RE: Depleted Uranium Performance Assessment (DUPA)
Clive Facility
Model Version 1.4 Amended Interrogatories
Radioactive Materials License #2300249

**UTAH DEPARTMENT OF ENVIRONMENTAL QUALITY
ENERGYSOLUTIONS CLIVE LLRW DISPOSAL FACILITY
RML #UT 2300249**

STATUS OF INTERROGATORIES

Figure 3. Deposition distributions.

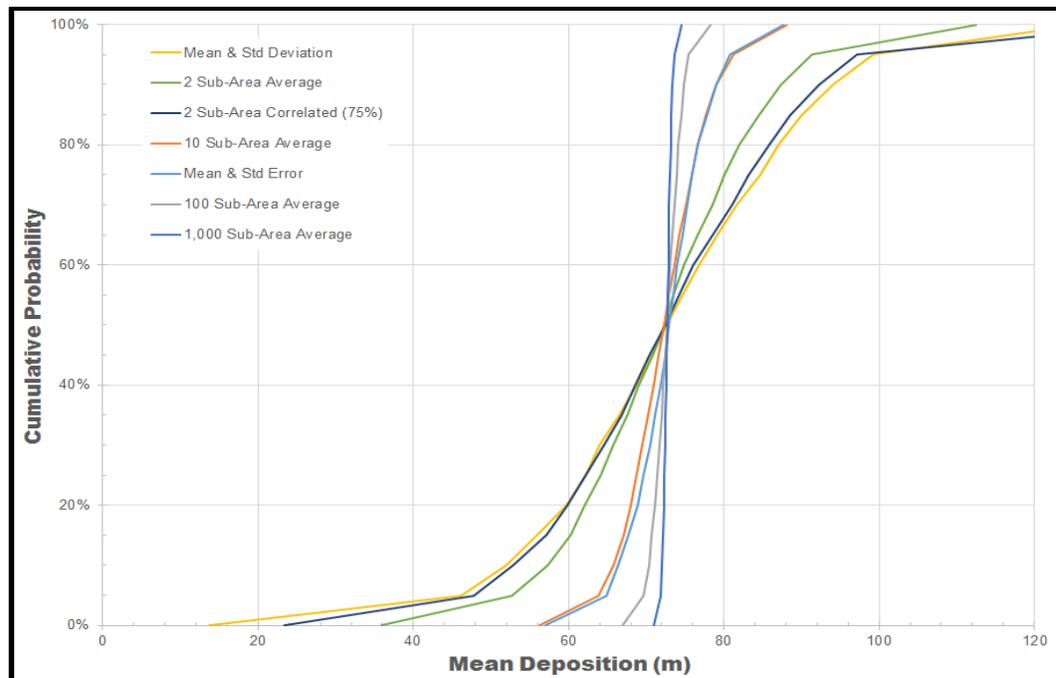
If the disposal embankment is divided into two subareas, and the mean and standard deviation of the 11 measured aeolian deposition thickness are applied independently to each, then the total embankment average deposition would differ from a single deposition calculated from the same mean and standard deviation. This is because in the two-subarea case, every time an extreme deposition is calculated for one subarea, the other subarea will have a less extreme deposition, so that the embankment average would always be less extreme than the single mean and standard deviation extreme. When this is repeated a large number of times, it results in a deposition distribution for the two subarea case that is narrower than the distribution for the single embankment area case. This is shown in Figure 3 below.

As the embankment is divided into ever more subareas, the resulting deposition distribution will become ever more narrow, until it reaches its limit at the mean. This is true even though the same mean and standard deviation have been independently applied to each of the subareas. Again, Figure 3 above shows this for 10, 100, and 1,000 subareas.

- 1) Deposition in the subareas of the embankment is likely correlated, rather than independent. A correlated model would produce results that are more conservative than the current EnergySolutions/Neptune model. However, the degree of correlation is presently unknown (and perhaps unknowable).

Figure 6. GoldSim model cover thicknesses for three realizations

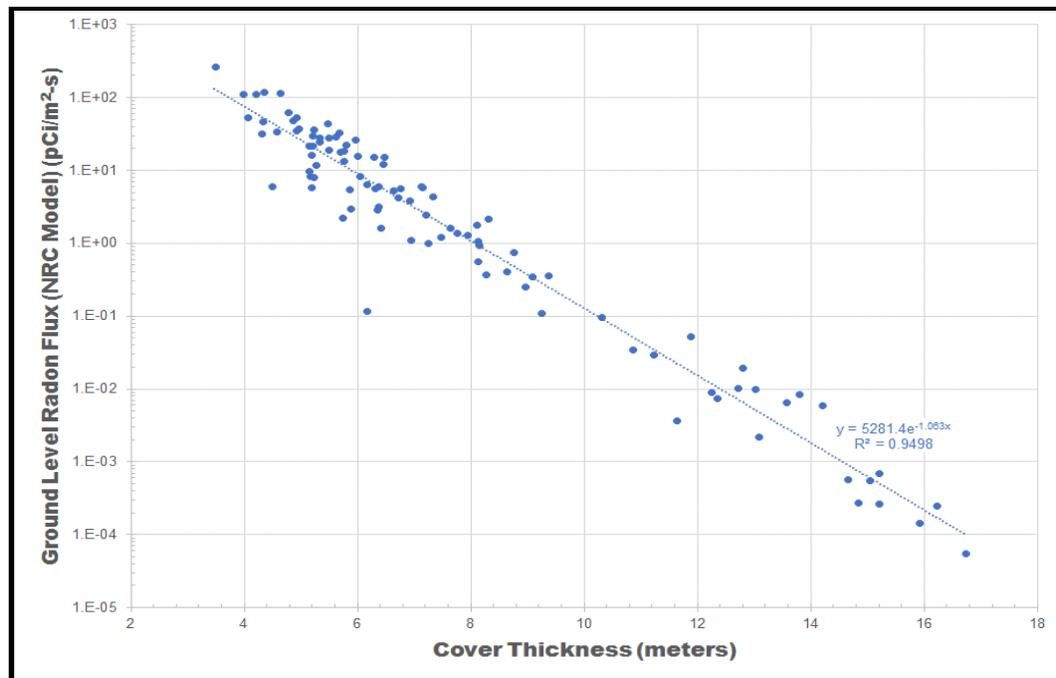
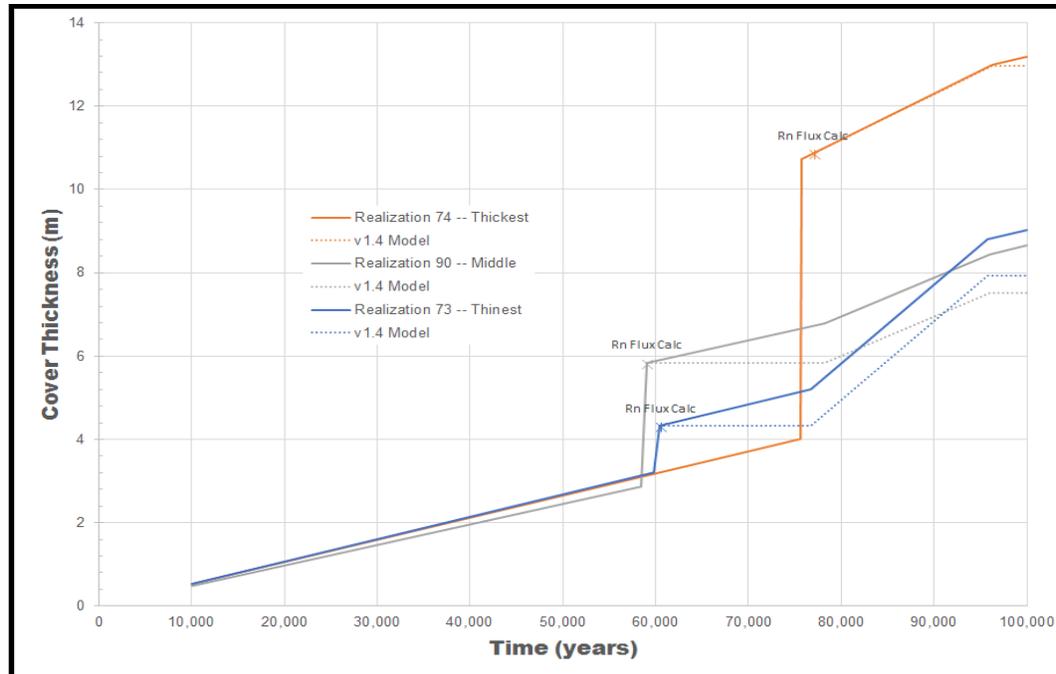
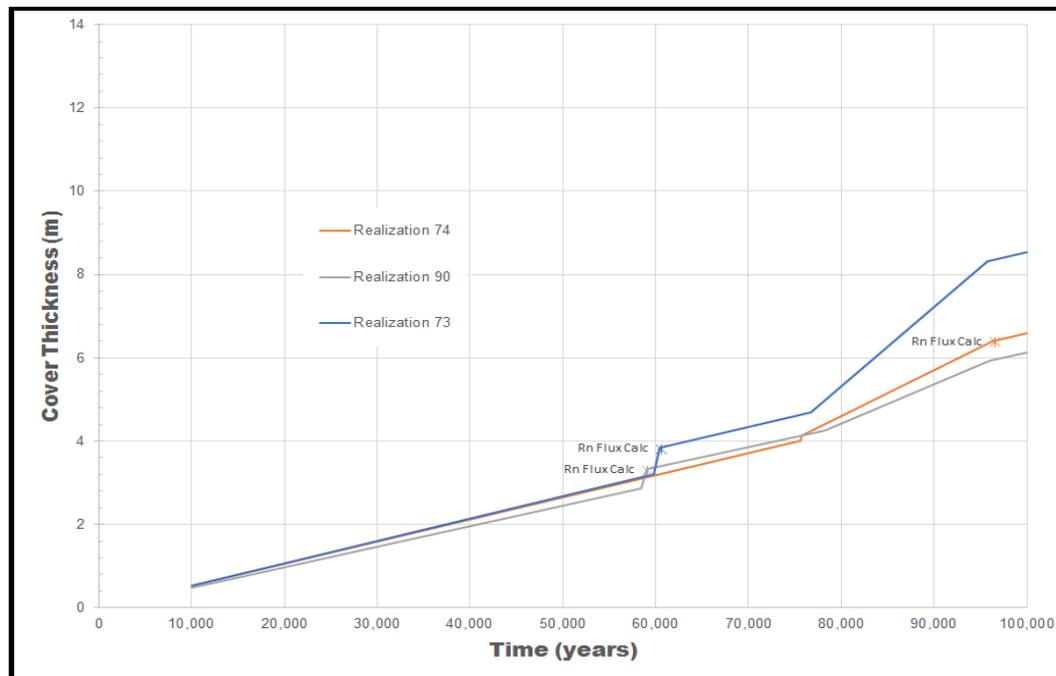
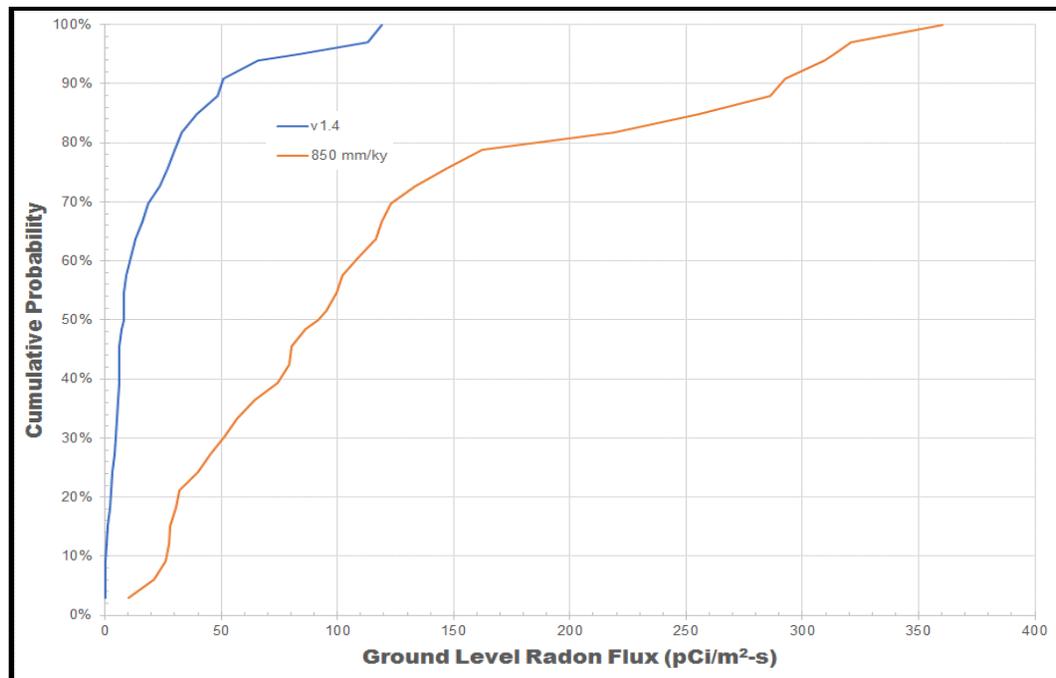
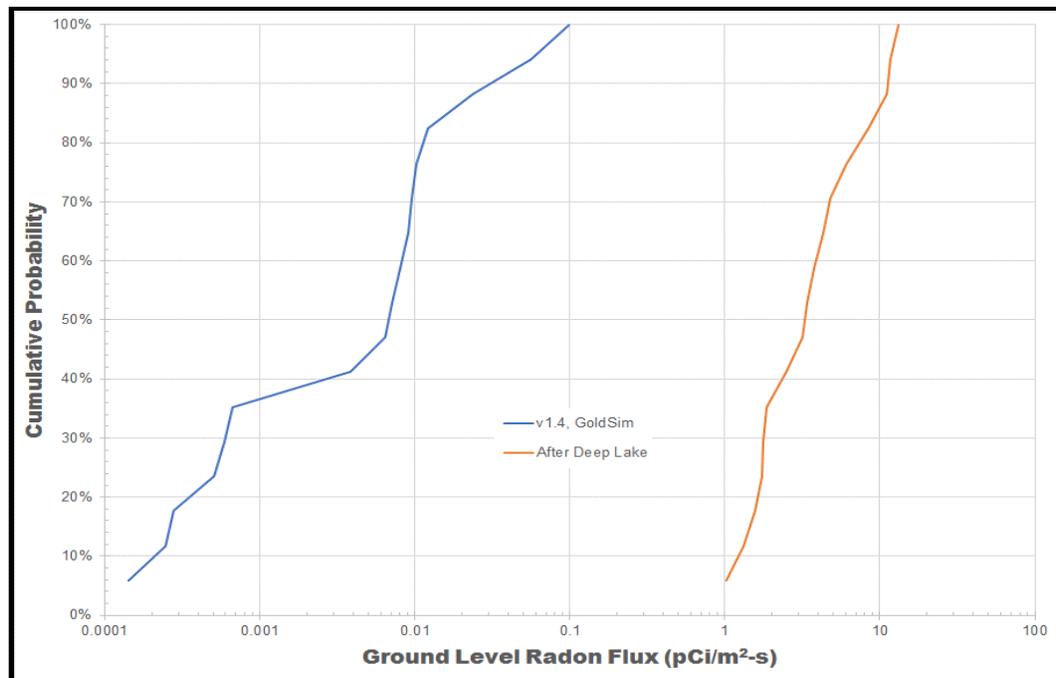
Unfortunately, because v1.4 shuts off aeolian deposition once the first Intermediate Lake appears (i.e., FirstIntermediateLakeAppears is set to “true” and there is no trigger to reset it to “false,” which is needed to allow aeolian deposition to resume), the GoldSim v1.4 model peak radon flux appears up to 29,500 years after the appearance of the first Intermediate Lake (i.e., the radium-226 continues to build up but the cover thickness remains unchanged).

Because the GoldSim v1.4 model resamples the Intermediate Lake sedimentation after each lake, it is only possible to check those realizations that include a single Intermediate Lake before a Deep Lake. The 100-realization run that SC&A made includes 33 realizations with a single Intermediate Lake before a Deep Lake. Figure 6 shows the cover thickness time histories for three of those 33 realizations: Realization 74 that has the largest Intermediate Lake sedimentation, Realization 73 with the smallest Intermediate Lake sedimentation, and Realization 90 with a middle amount of Intermediate Lake sedimentation. The solid lines in Figure 6 were developed for this study using a combination of GoldSim results and hand calculation. SC&A conducted two hand calculation checks of the GoldSim results: (1) the cover thickness at the time when the First Intermediate Lake recedes and 2) the cover thickness at 100,000 years. The first check confirmed the GoldSim results, while the second check showed that the GoldSim model does not include aeolian deposition after the first Intermediate Lake recedes. The dotted lines in Figure 6 show the GoldSim v1.4 model-calculated thickness, which ignores aeolian deposition after the first Intermediate Lake.

In Figure 6, notice the essentially “step changes” in cover thicknesses that occurs when the Intermediate Lake is present. We can think of no physical process that could be responsible for

As mentioned above, the DEQ/SC&A review of the GoldSim v1.4 Deep Time model identified the following logic bugs:

1. When a Deep Lake appears before an Intermediate Lake (which occurs in about 15 percent to 20 percent of the realizations), the radon flux (and other results) is not calculated when the Deep Lake recedes, but rather the model waits for an Intermediate Lake and calculates the radon flux (and other results) once the Intermediate Lake recedes. For the realizations affected, the potential impact of this bug on the radon flux is shown in Figure 9, which shows at least two (and up to almost four) orders of magnitude increase in the calculated radon flux when this bug is corrected.

2. When a Deep Lake appears before an Intermediate Lake, aeolian deposition continues to accumulate when the Deep Lake is present, overcalculating the cover thickness.

3. When an Intermediate Lake appears first, aeolian deposition remains off after the lake recedes, even before and after the Deep Lake. This does not affect the radon flux calculation, since that occurs when the Intermediate Lake recedes, but it does undercalculate the cover thickness at 100,000 years (see the dotted lines in Figure 6).

In conclusion, this interrogatory remains open, and the v1.4 Deep Time GoldSim model is currently unacceptable. Three actions are needed to close this interrogatory: (1) a more realistic Intermediate Lake total sedimentation or sedimentation rate needs to be developed, (2) Appendix 13 of the DU PA needs to be revised to correctly describe the deep time model, and (3) the logic bugs need to be removed from the GoldSim model.

Figure 10. Water balance graphs showing temporal variation in water balance quantities for sites in California (a) and Montana (b). The soil water storage capacity of the cover is shown on each graph.

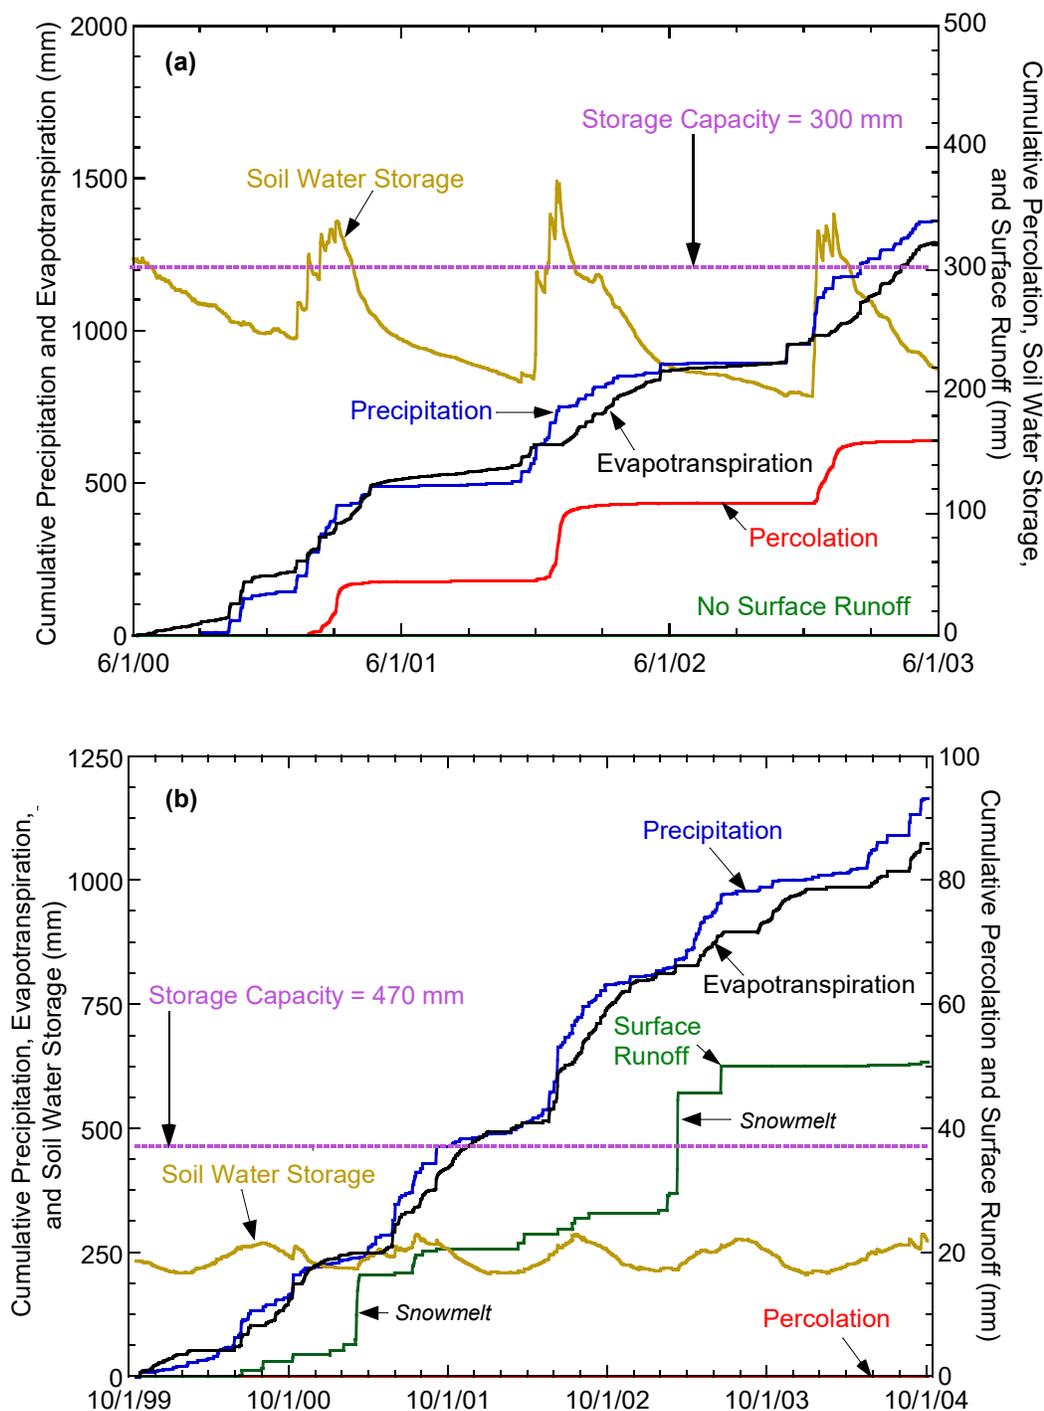
Additional quantitative and mechanistic evidence is needed to support the outcomes in this part of the report. Water balance graphs, which depict the temporal variation in water balance quantities (rather than a water balance quantity chart) should be used to illustrate whether the outcomes are reasonable. Water balance graphs typically are created using daily output predicted from a water balance model and show the seasonal variation in each water balance quantity. Examples of water balance graphs are shown in Figure 10. These graphs depict actual water balance data; water balance graphs from a model prediction would be similar. The soil water storage record in the water balance graph would be compared to the soil water storage capacity of the eroded profile.

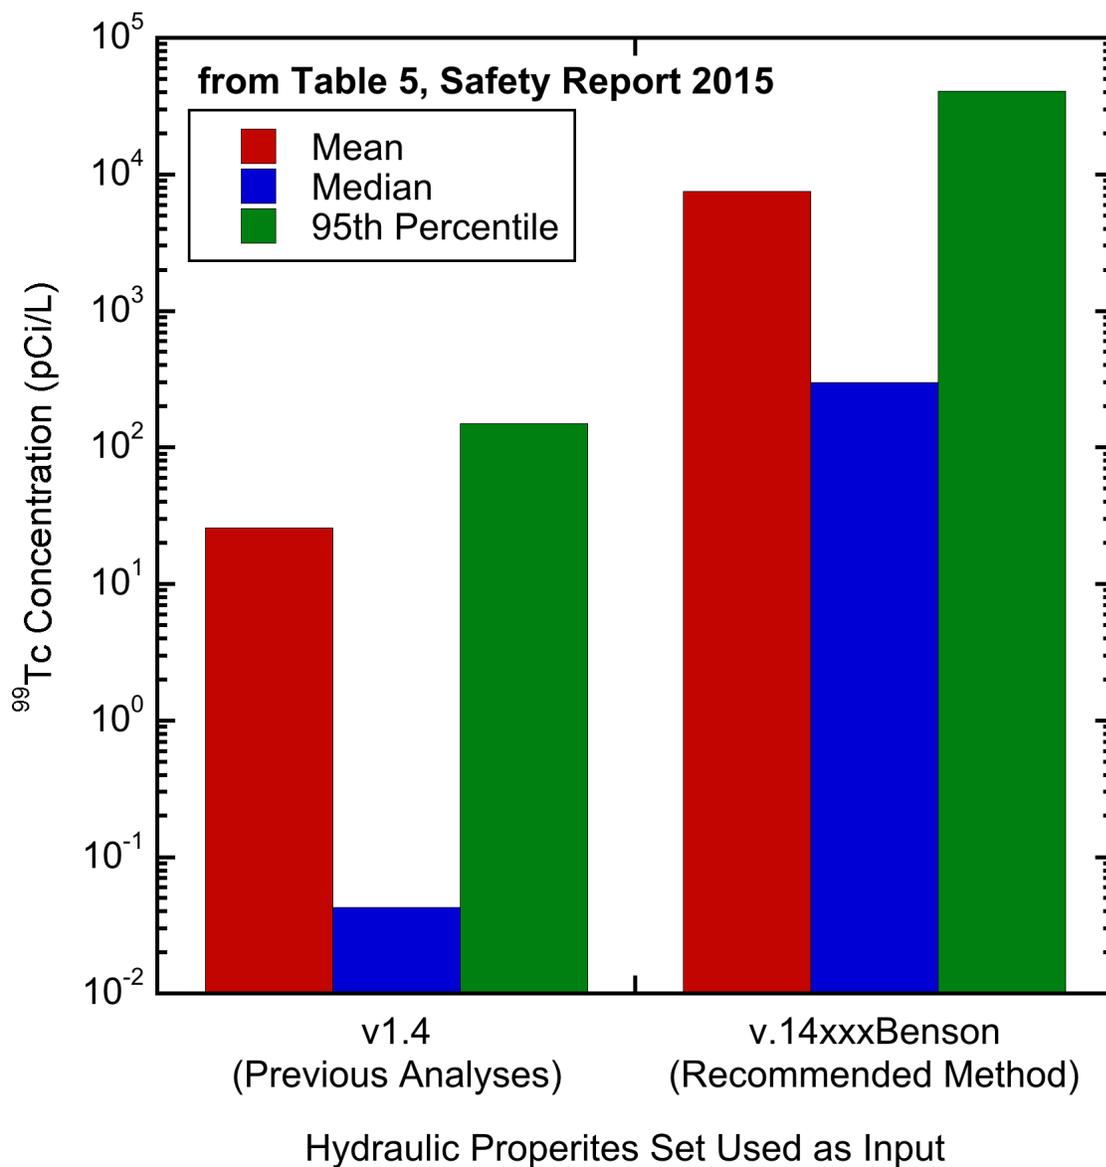
Significantly higher Tc-99 concentrations were obtained for percolation rates predicted using the hydraulic properties EnergySolutions developed with the recommended approach (Appendix E, April 2015 SER) relative to the percolation rates predicted in their previous analyses (Figure 11). The differences are very large, which is difficult to understand given that the percolation rates predicted for the cover are on the order of 1 mm/yr and are consistent with percolation rates measured for covers placed at other sites in the region.

If the impact on groundwater concentrations is this sensitive to percolation rates on the order of 1 mm/yr, then detailed assessment and proof of the cover design should be particularly important. EnergySolutions should consider installing a lysimeter to confirm that the cover modeling is reliable.

Figure 12. Probability density functions for saturated hydraulic conductivity apparently used as input in the models described in the 2014 and 2015 unsaturated zone modeling reports

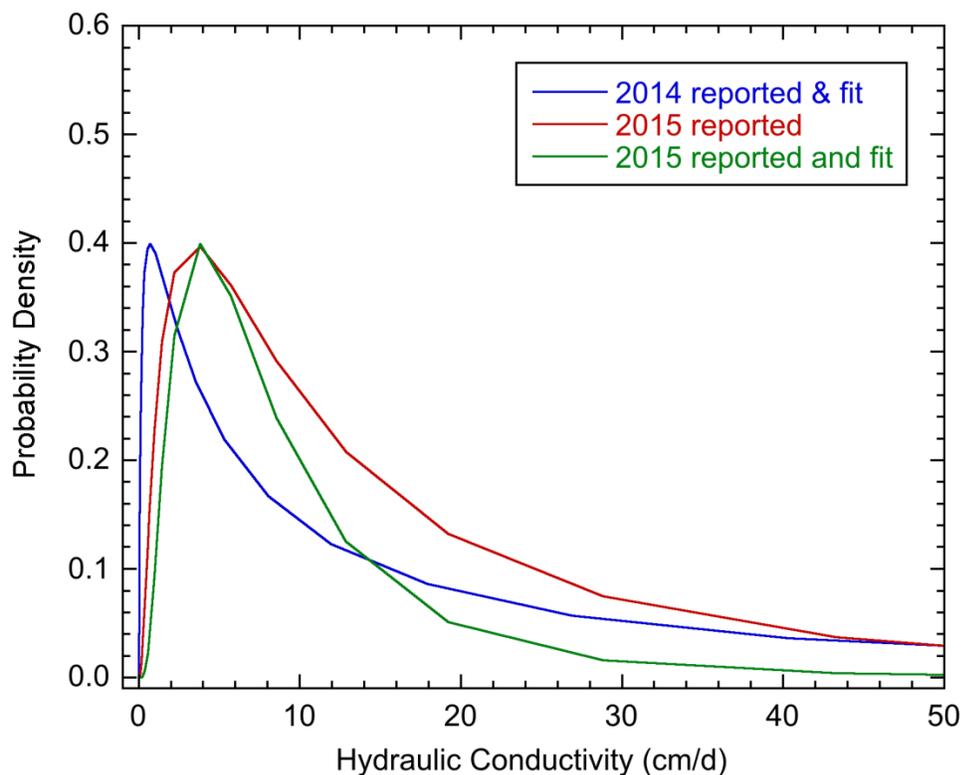
Probability density functions (PDFs) are shown in Figure 12 that were used to describe uncertainty and spatial variability in the saturated hydraulic conductivity of the radon barrier in the unsaturated zone modeling reports submitted in June 2014 and October 2015 (Neptune 2014b, 2015e). A PDF is analogous to a histogram, describing the probability density associated with a particular value of the random variable for a defined probability distribution (in this case, the three-parameter lognormal distribution). The distributions for 2014 and 2015 were parameterized to the extent practical using the methodology described in the 2014 and 2015 Unsaturated Zone modeling reports. A three-parameter lognormal distribution was used, given that the 2014 and 2015 reports indicate that a lower bound > 0 was stipulated in the 2014 and 2015 reports. A description of the three-parameter lognormal distribution can be found in Zhai and Benson (2006).

The PDFs in Figure 12 provide insight into the unexpected outcomes for the percolation rates predicted in 2014 and 2015, the latter percolation rates being lower despite substantially higher geometric mean saturated hydraulic conductivity. For the PDF marked “2015 reported and fit,” which seems to be the PDF most likely used as input to the model, the upper tail of the distribution is much lighter than for the 2014 PDF (e.g., the probability of high hydraulic conductivities is lower in the 2015 modeling). Consequently, the percolation rates tend to be lower in the 2015 report relative to those in the 2014 report. This would not be the case if the parameters corresponding to “2015 reported” were used as input to the model, as the PDF for this case generally has a heavier upper tail relative to the PDF used as input to the 2014 model.

This ambiguity highlights an important issue: reports issued by EnergySolutions should include sufficient information for an independent party to reproduce the outcomes without ambiguity. At a minimum, probabilistic descriptions should show a mathematical description of the distribution employed (e.g., probability distribution and definition of parameters) and a list of the values assigned to each parameter for each case being analyzed.
